903050:MSK
3311/2011-502

This is in reference to your sample, as well as accompanying correspondence, which was submitted to the Firearms Technology Branch (FTB), Bureau of Alcohol, Tobacco, Firearms and Explosives (ATF). You have submitted this item, consisting of a Chinese, Type 56 (SKS) rifle and a stock of your own manufacture, with a request for classification under the National Firearms Act (NFA).

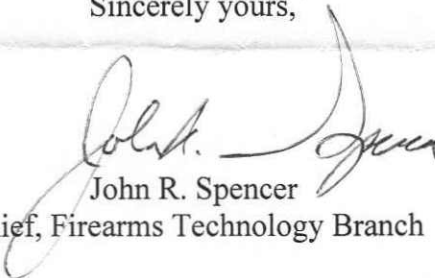
- A metal block which secures the SKS trigger mechanism to the remainder of the weapon (a function formerly accomplished by the weapons factory stock). A metal rod is attached and protrudes from the rear section of this metal block. This rod rides within a bushing inletted into the rear portion of your "ALM" stock.
- A second metal block which has been machined to allow the three guide rods located in the front portion of your stock to pass through it. This component serves as a support for the front portion of the SKS rifle and as an attachment to the modified stock.
- A forward hand guard/gripping surface which is attached to the bottom portion of the second metal block noted above.
- Lack of any operating springs, bands, or other devices which would permit automatic firing.

Your ALM stock is designed to allow the SKS rifle mounted within it to reciprocate back and forth in a linear motion. The absence of an accelerator spring or similar component in the submitted device prevents the device from operating automatically as described in ATF Ruling 2006-2. When operated, forward pressure must be applied to the above noted forward hand-guard/gripping surface with the support hand, bringing the receiver assembly forward to a point where the trigger can be pulled by the firing hand. If sufficient forward pressure is not applied to the hand guard with the support hand, the rifle can be fired in a conventional semiautomatic manner since the reciprocation of the receiver assembly is eliminated.

The FTB live-fire testing of the submitted device indicates that if, as a shot is fired and a sufficient amount of pressure is applied to the hand guard/gripping surface with the shooter's support hand, the SKS rifle assembly will come forward until the trigger re-contacts the shooter's stationary firing-hand trigger finger, allowing a subsequent shot to be fired. In this manner, the shooter pulls the receiver assembly forward to fire each shot, each shot being fired by a single function of the trigger.

Since your device does not initiate an automatic firing cycle by a single function of the trigger, FTB finds that it is NOT a machinegun under the NFA, 26 U.S.C. 5845(b), or the GCA, 18 U.S.C. 921(a)(23).

Please note that this classification is based on the item as submitted. Any changes to its design features or characteristics will void this classification. Moreover, we caution that the addition of an accelerator spring or any other non-manual source of energy which allows this device to operate automatically as described in Ruling 2006-2 will result in the manufacture of a machinegun as defined in the NFA, 26 U.S.C. 5845(b).
